Department of Environmental Quality

RE: DEQ Comments on *Siltronic Operable Unit Remedial Investigation Data Summary Report*  
Siltronic Corporation  
Portland, Oregon  
ECSI No. 183

**Figure 2**  
Southern Siltronic Site Operable Unit (Siltronic OU)  
(boundary is approximate)

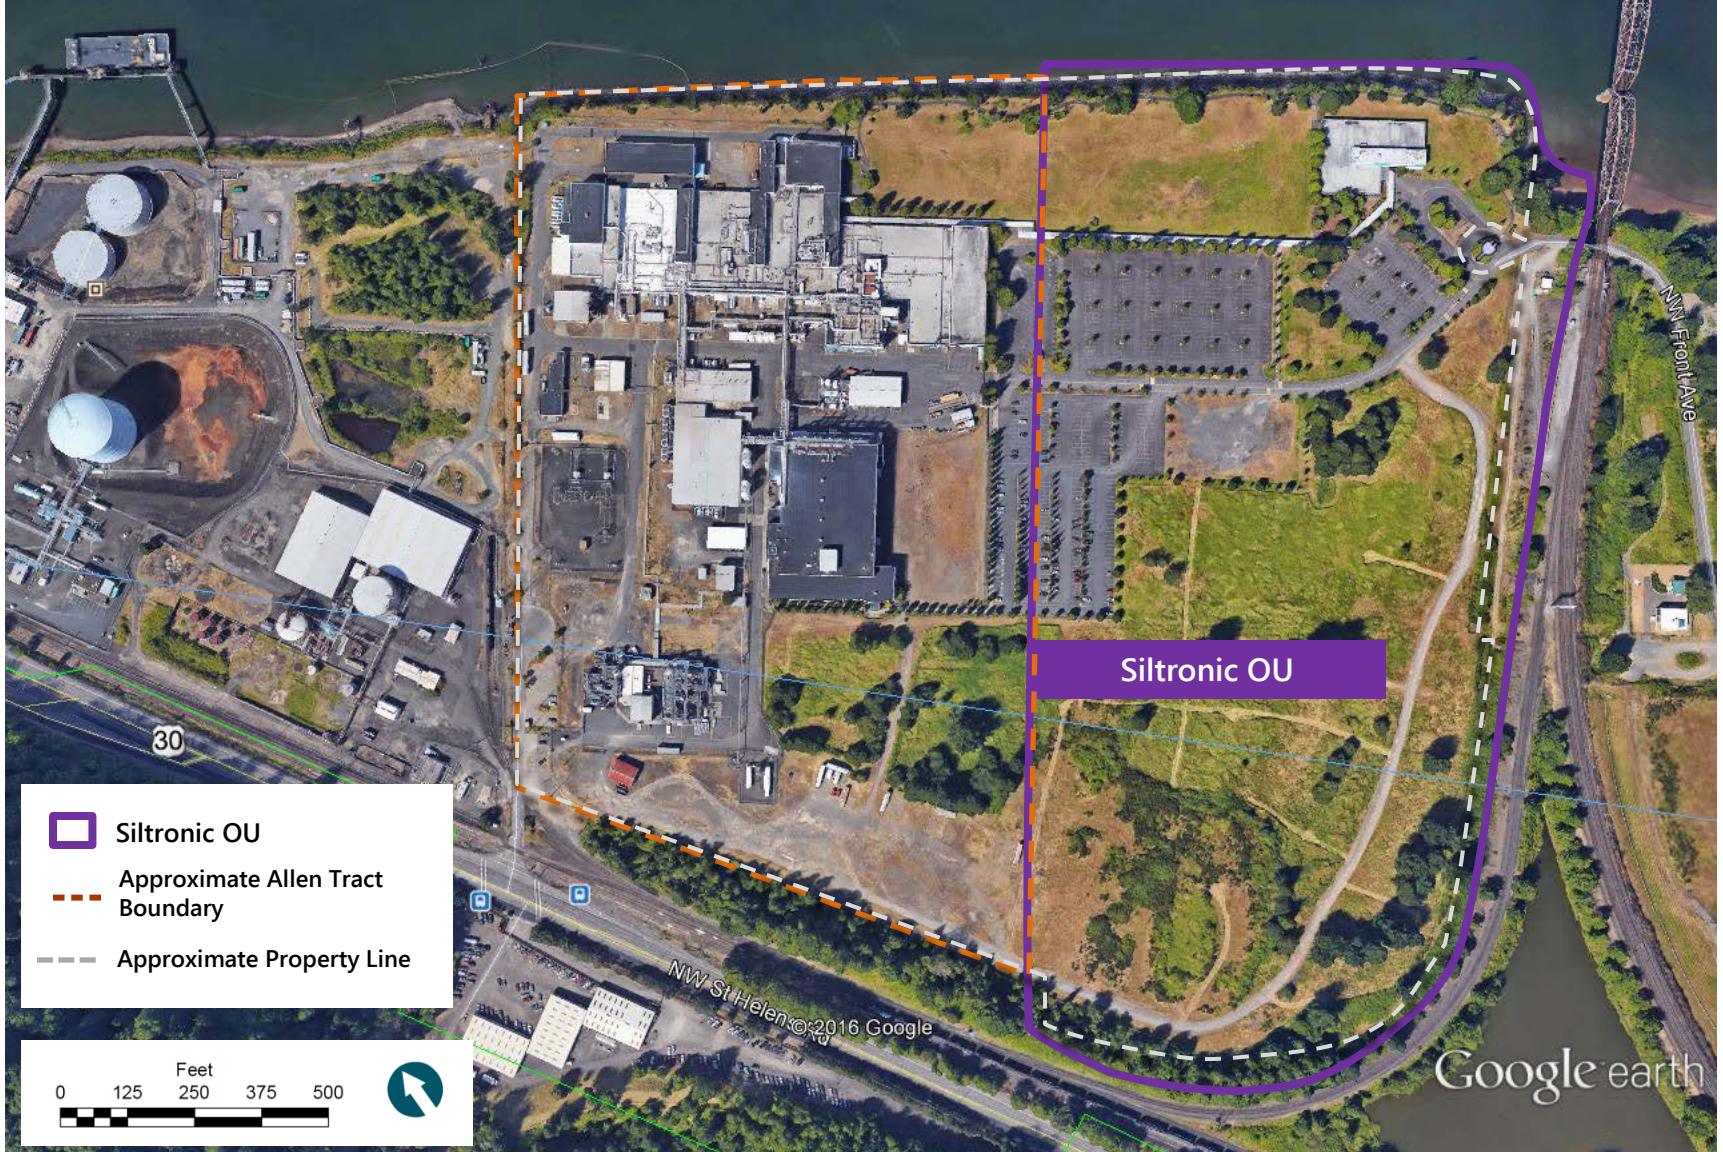
- 8. Figures.** The Siltronic OU boundary is incorrectly shown on the Data Summary Report Figures. All future submittals must correctly show the Siltronic OU boundary, as drawn on Exhibit A of the 2016 Unilateral Order between Siltronic and DEQ (DEQ Order No. OPSR-NWR-16-02) and attached to this letter as Figure 2.
